Rezoning Transportation Analysis

Petition Number: 2026-033

General Location Identifier: 20108104

Date	Description
6-25-26	First Review (CM)
7-21-26	Second Review (DR)

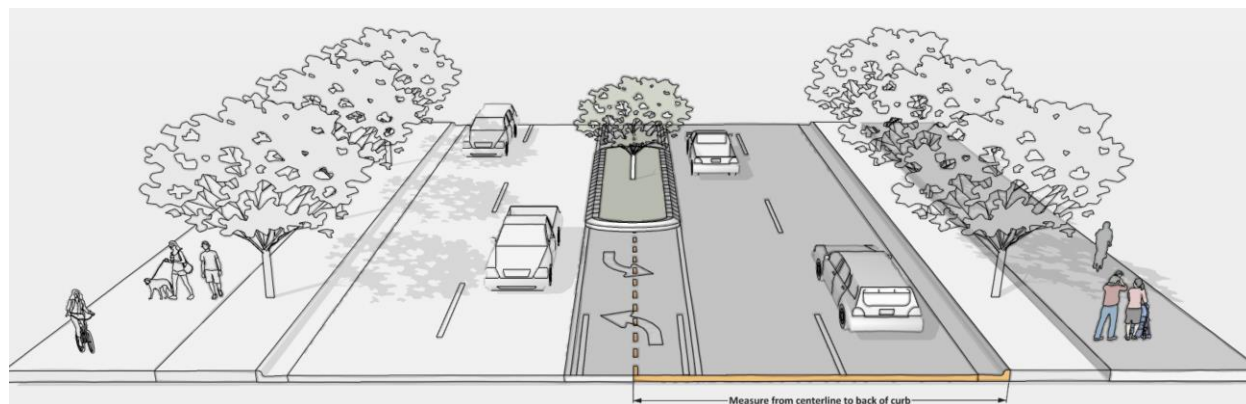
3. **07-22-26 Outstanding Comment from 06-25-26:** Revise site plan and conditional note(s) to dedicating 50-feet of right-of-way from the road centerline. The site plan shall label and dimension the right-of-way from the road centerline.

Clarifying Comment 7/21/26: Add labeled and dimensioned for the Right-of-way not on the site plan.

14. **New Comment 7/21/26:** A couple of text edits for this site plan. Revise all references to say shared-use path instead of multi-use path.

PROP. FUTURE 12' **MULTI-USE PATH** TYP.
(CLDSM 10.42)

Revise below to say 'and'.

15. **New Comment 7/21/26:** Per NCDOT, add a note to the development standards that says, "Developer to provide dedicated right turn lane into the site in coordination with NCDOT and CDOT. Design to be finalized during permitting."
